CPED STAFF REPORT

CPC Agenda Item #4
 October 14, 2014
 BZZ-6724

Project Name: Children’s Minneapolis Master Plan

Request: To allow for the construction of a 6,700 square foot clinic within the footprint of the existing Mother Baby Center

A1 WEST ELEVATION
1/8" = 1'-0"

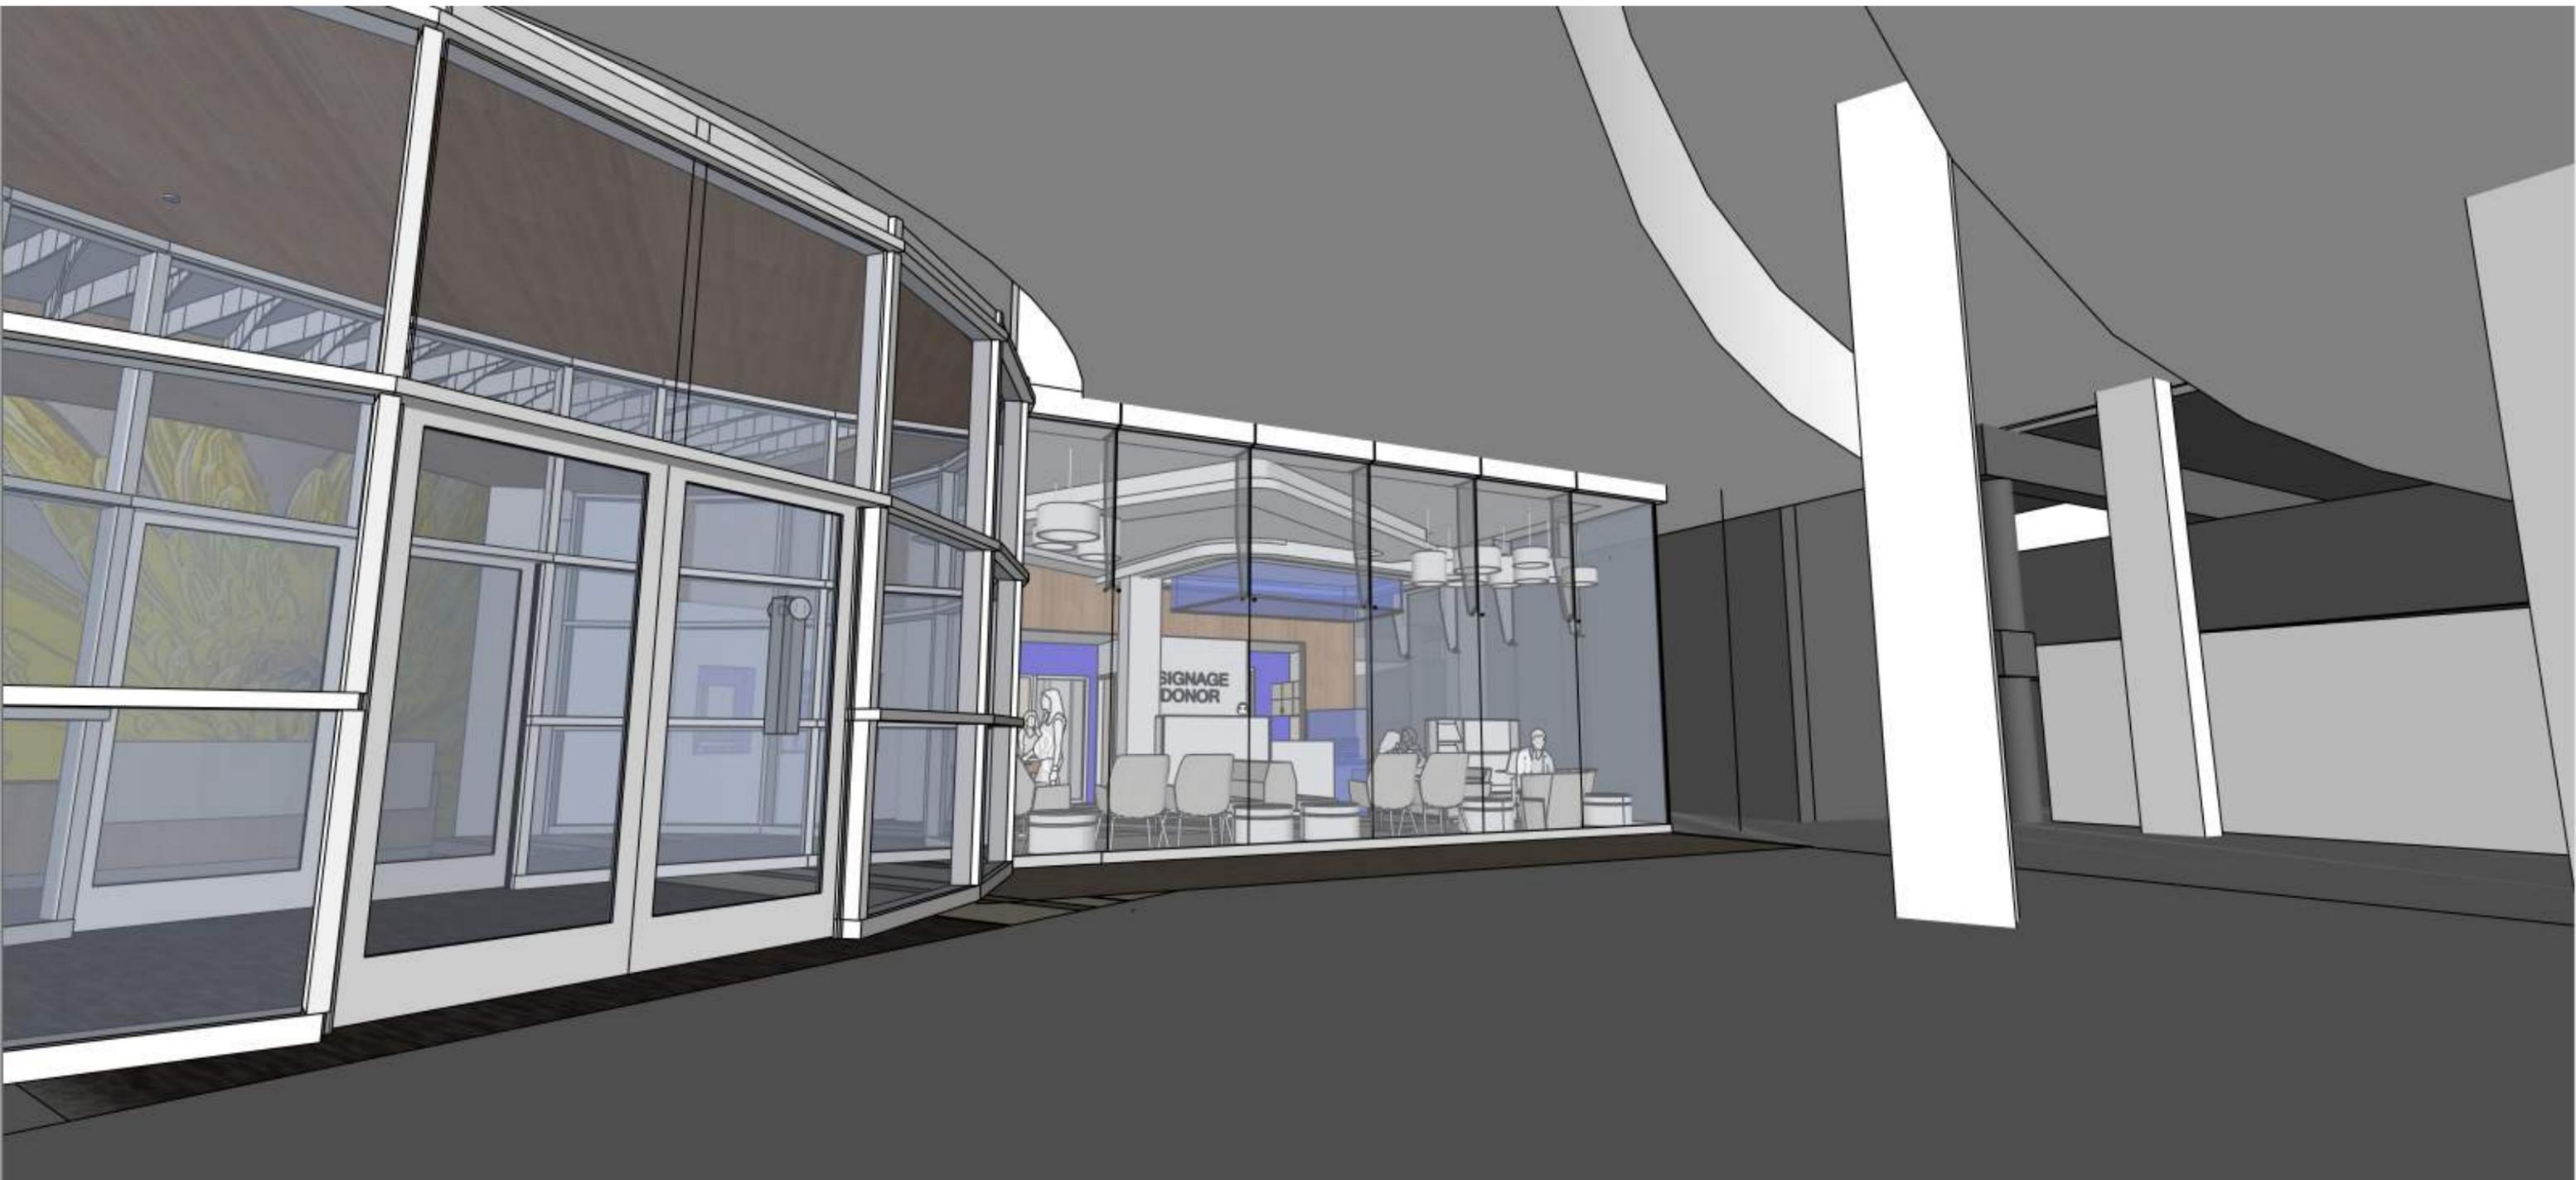
- **Blank walls.** The north and west elevations each contain sections of blank wall that exceed 25 feet in length. Neither of these walls is visible from the remainder of the development as they face the interior of the site directly abutting other buildings. As such, staff recommends granting alternative compliance to allow blank walls in excess of 25 feet.

- **Durable materials.** The applicant is proposing to use EIFS as the primary exterior material on the west elevation. While this elevation will be interior to the site and face the adjacent parking

ramp, staff does not recommend granting alternative compliance due to concerns about durability and longevity. As a condition of approval, the primary exterior material for the west elevation shall be stucco to match the north and east elevations.

1. EIFS shall not be allowed as an exterior material per Section 530.120 of the zoning code. The west elevation shall be revised to include stucco as the primary exterior material, matching the north and east elevations.
2. Signage shall comply with the applicable requirements of Chapter 543 of the zoning code and the previously approved master sign plan.
3. Department of Community Planning and Economic Development staff review and approval of the final building elevations, floor, site, plaza, lighting and landscape plans.
4. Site improvements required by Chapter 530 or by the City Planning Commission shall be completed by October 14, 2016, unless extended by the Zoning Administrator, or the permit may be revoked for non-compliance.
